# CERTIFICATE OF APPROPRIATENESS PLACARD

218 N EAST STREET

HECK-POOL HOUSE

## Raleigh Historic Development Commission – Certificate of Appropriateness (COA) Application

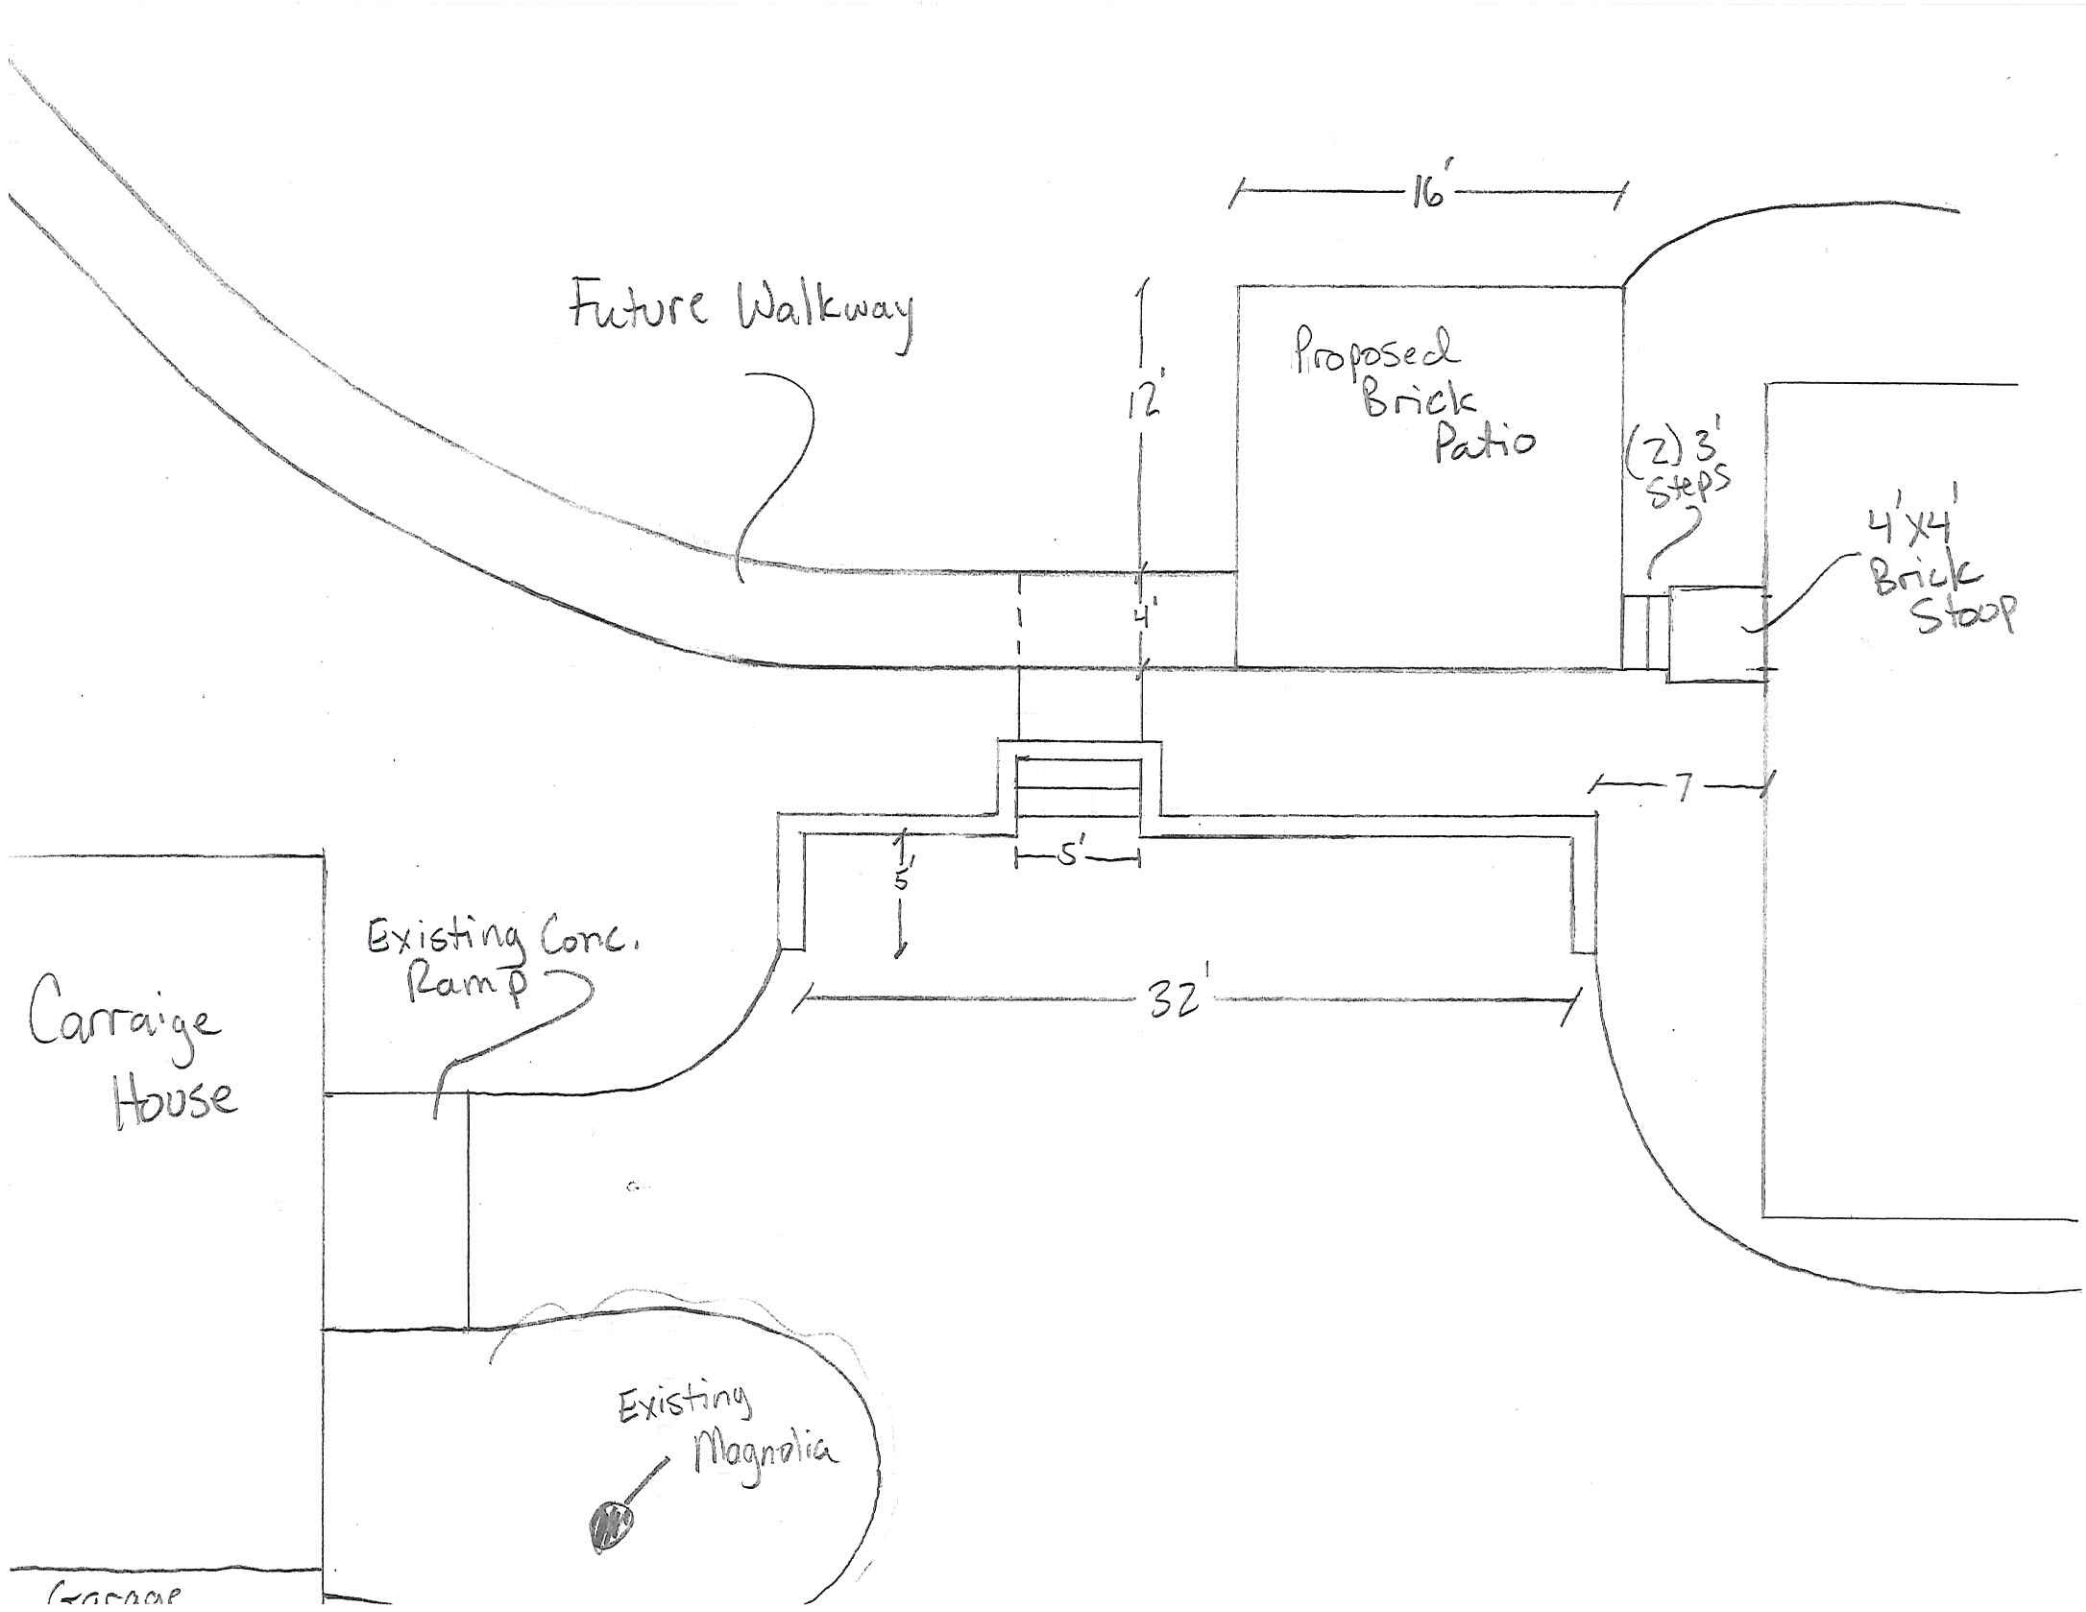
- What does the green highlight mean on the site plan?
- Provide a revised overall site plan that only shows items requested in this application. This needs to be either scaled or have dimensions.

Parking wall & steps/landing elevation

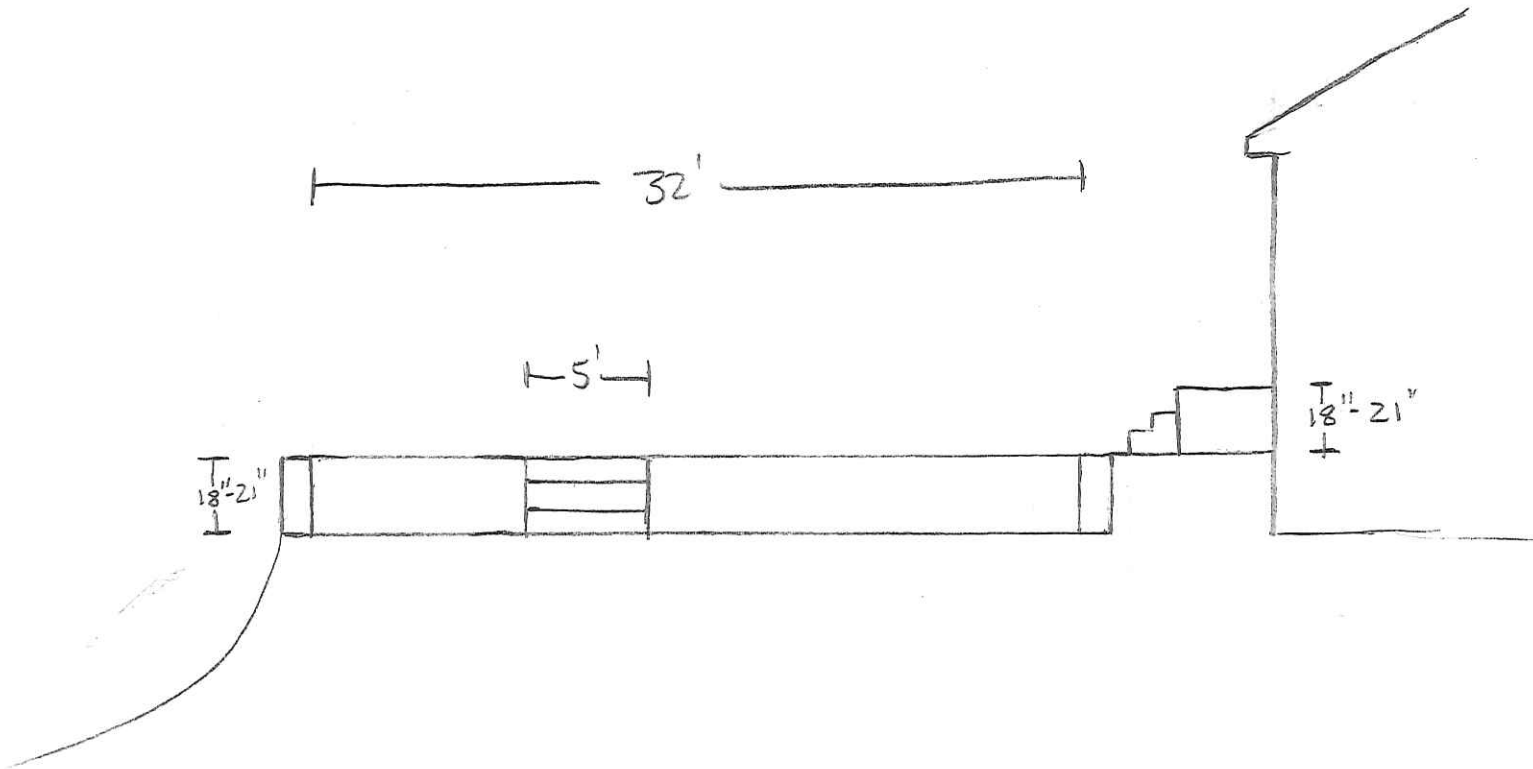
- Barn roof: provide specs on the ridge cap; also - a lower seam height would be more appropriate
- Is the decorative "wall" proposed at the rear entrance a retaining wall? If so it needs to be of some kind of masonry. Wood walls atypical of the district.

3. Parking wall: The drawings do not have a sufficient level of detail. Please provide the bond pattern, top of wall treatment, dimensions, etc.. A larger scale drawing and/or section drawing is recommended.

☐ The decorative parking wall is not a retaining wall. We've proposed to use the phoenix brick in the application.

3. Please see attached parking wall drawings that include required level of detail.

## 5V Profile

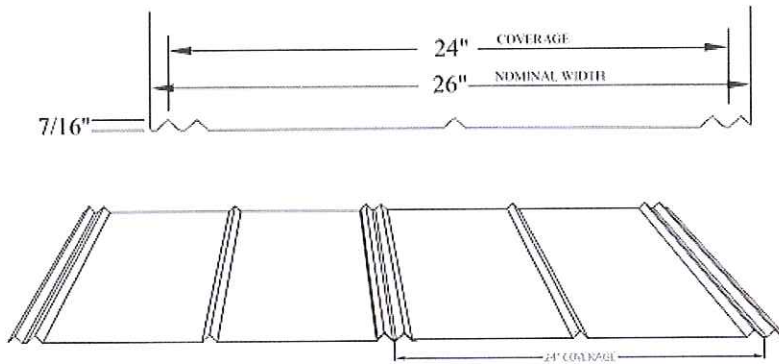
2. Metal roof: The ridge cap specs are still needed as well as clarification on the new seam height. All I see from the attached detail is a color change.

2. Metal roof: The ridge cap specs are still needed as well as clarification on the new seam height. All I see from the attached detail is a color change.

2. The new, proposed seam height for the 5V is 7/16" high ribs on 12 inch centers. Screen-shot of website spec drawing attached. The ridge cap is the Coastal Metal Service Classic Ridge Cap (specs attached)

# TOP VIEW

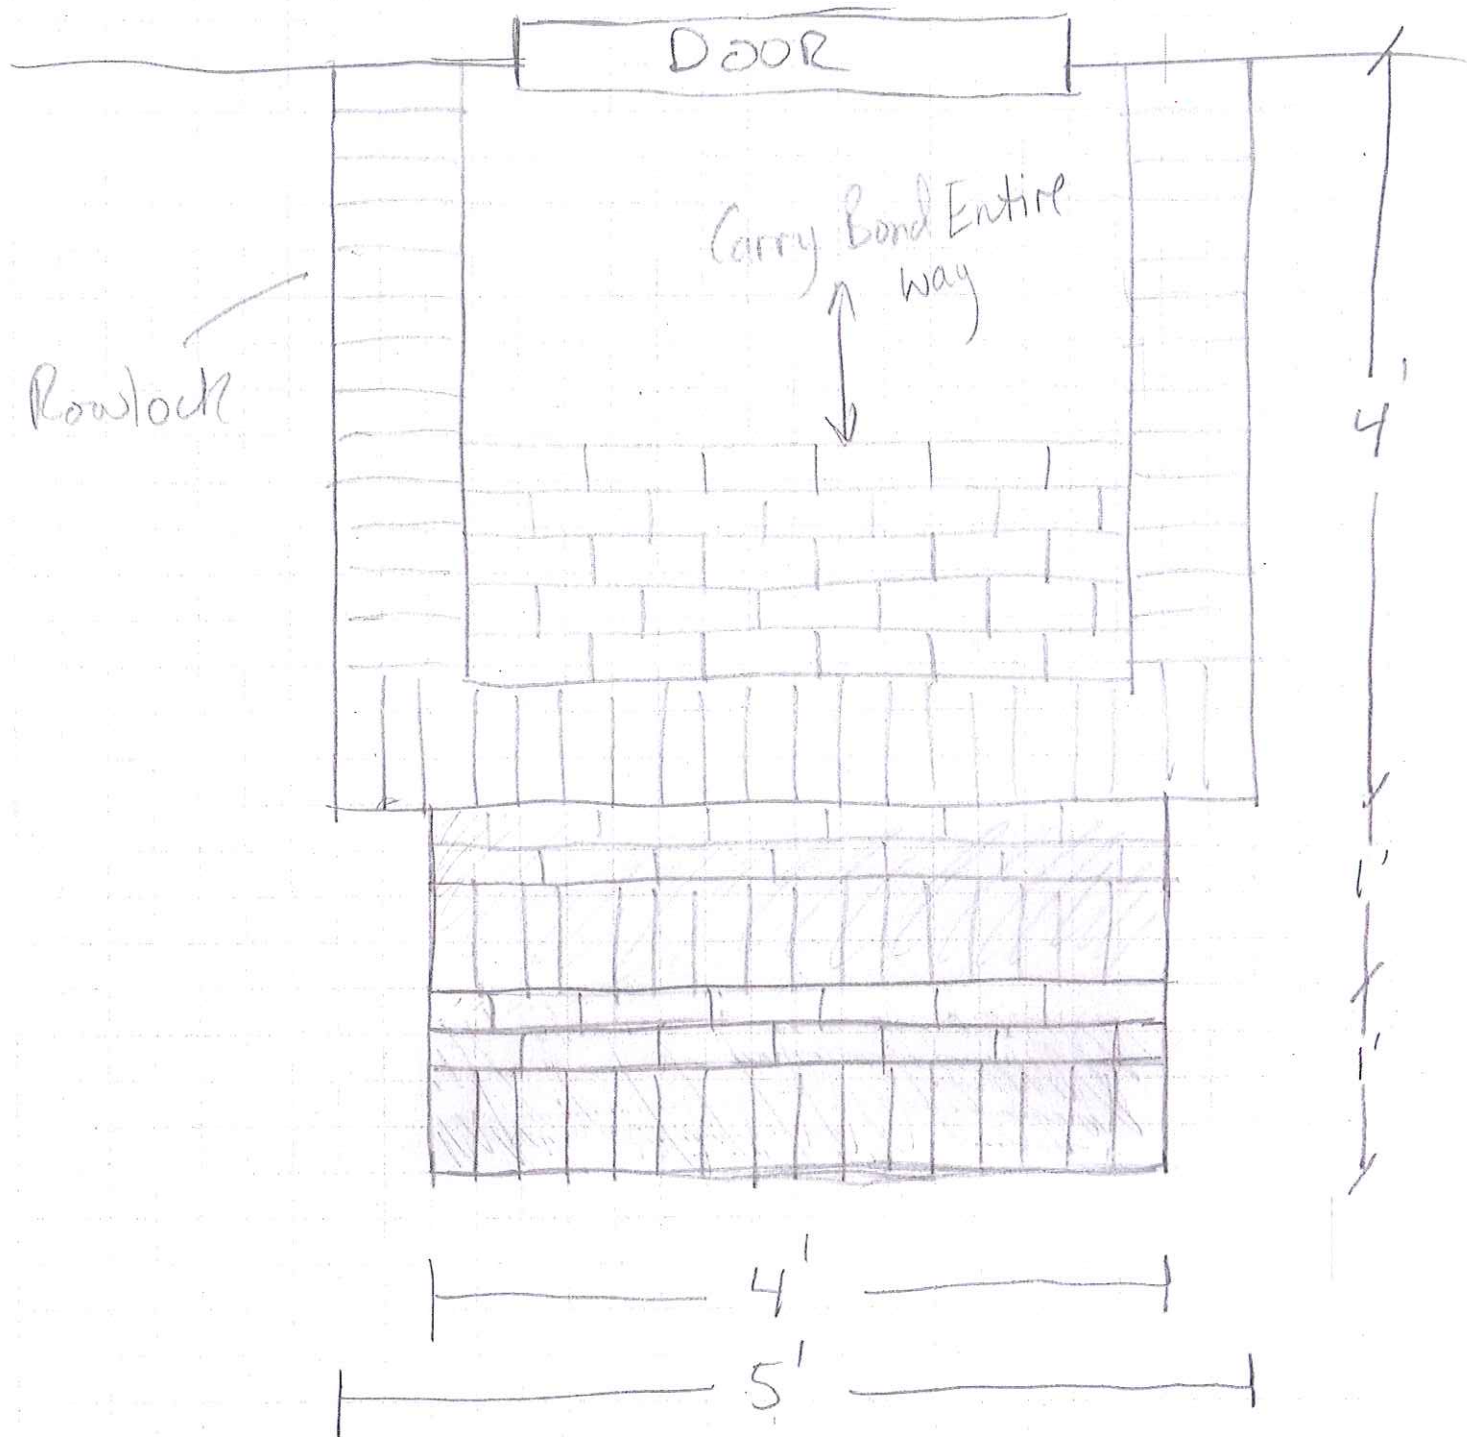
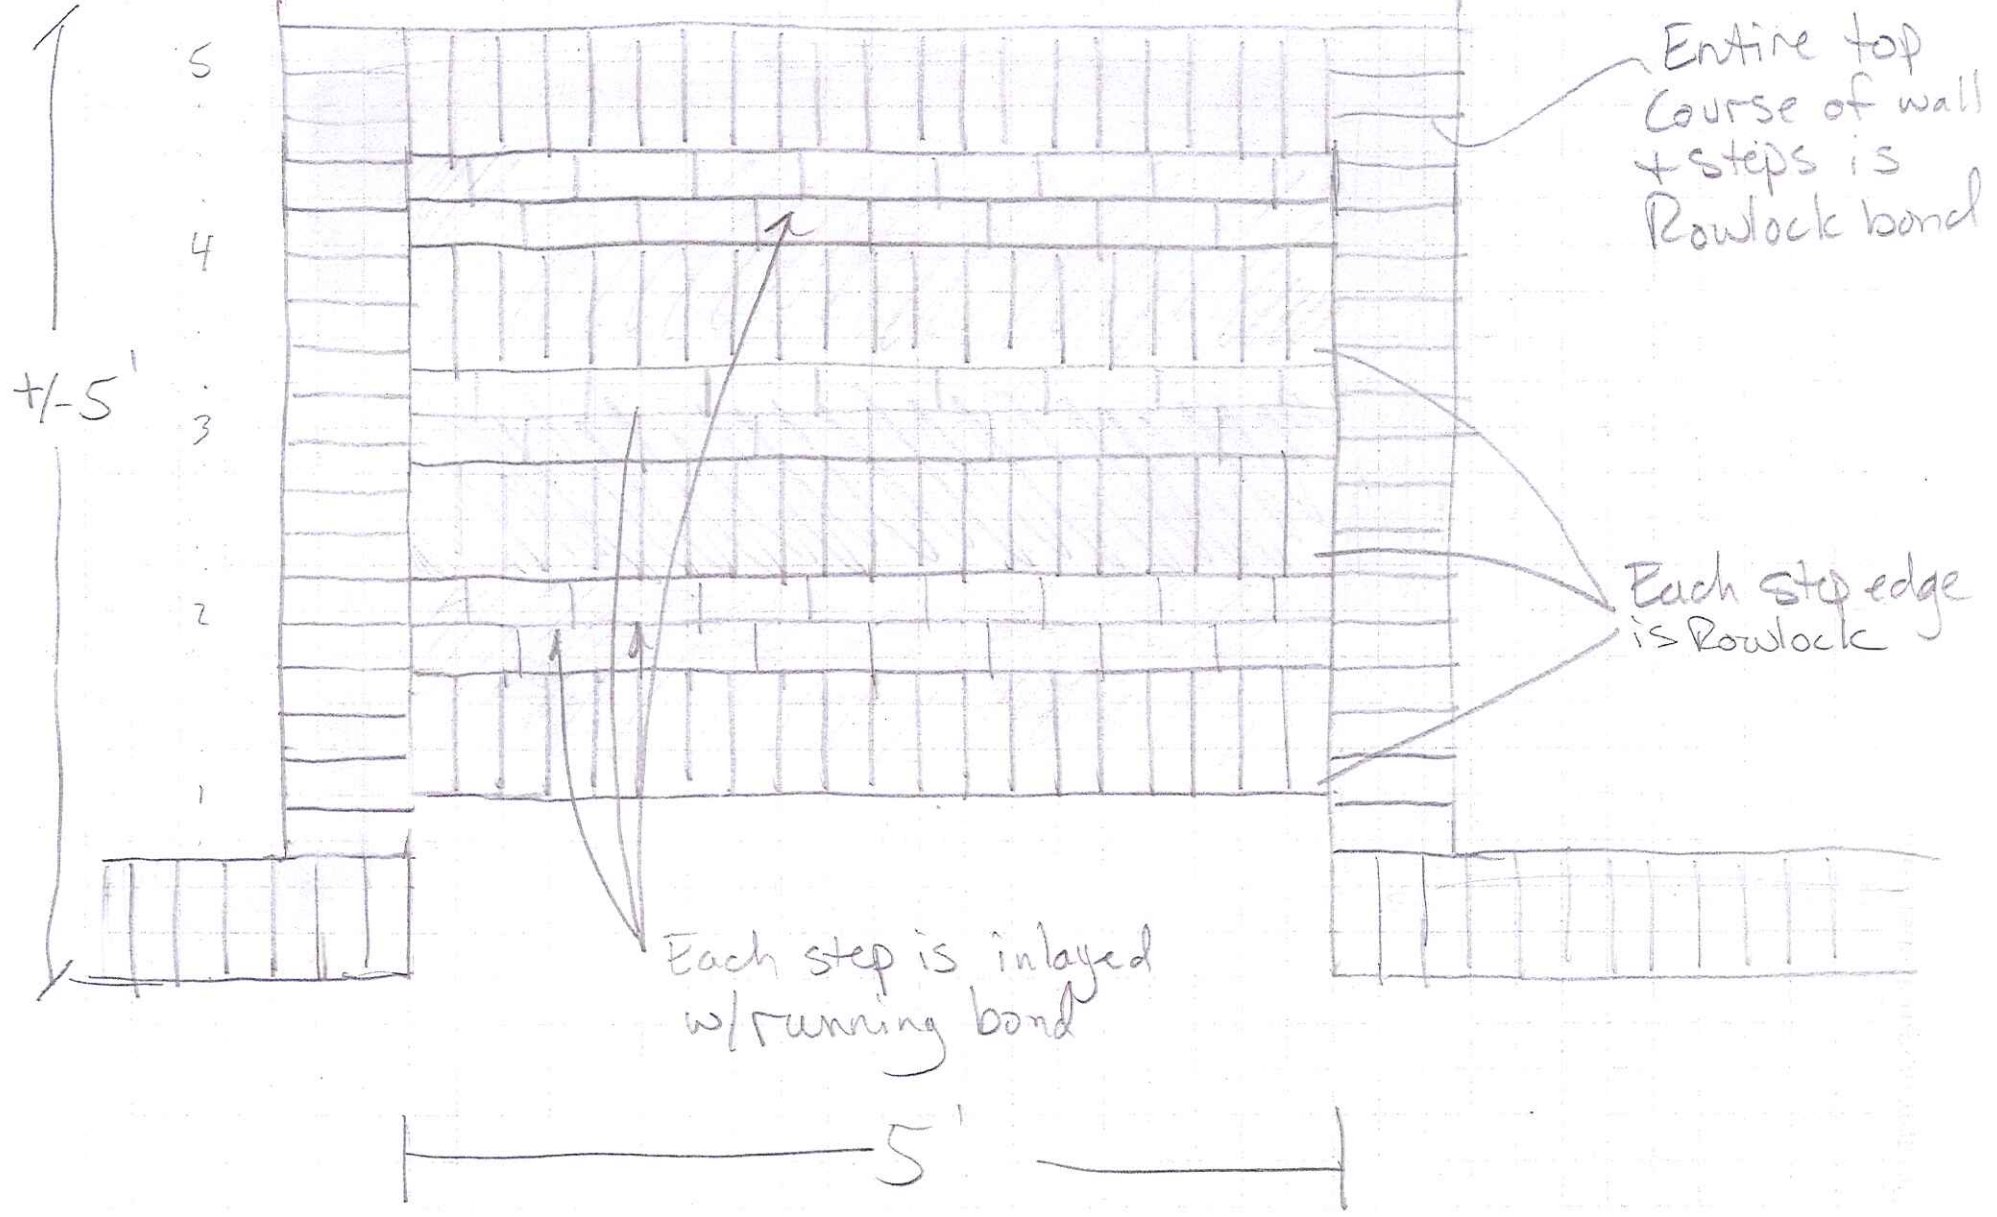
3. Parking wall: The drawings do not have a sufficient level of detail. Please provide the bond pattern, top of wall treatment, dimensions, etc.. A larger scale drawing and/or section drawing is recommended. -

4. Tree replacement: Where is the new Oak proposed to be planted?
5. Brick steps at patio: The drawings do not have a sufficient level of detail. A larger scale drawing and/or section drawing is recommended

Entire top of wall will be  
Rowlock  
Pattern

Entire vertical surface will  
be running bond pattern  
including steps

Each Step will be  
Rowlock Bond on top.  
Vertical surface of  
Step will be running bond

Entire top course of wall + steps is Rowlock bond

Each step edge is Rowlock

Each step is inlaid w/ running bond
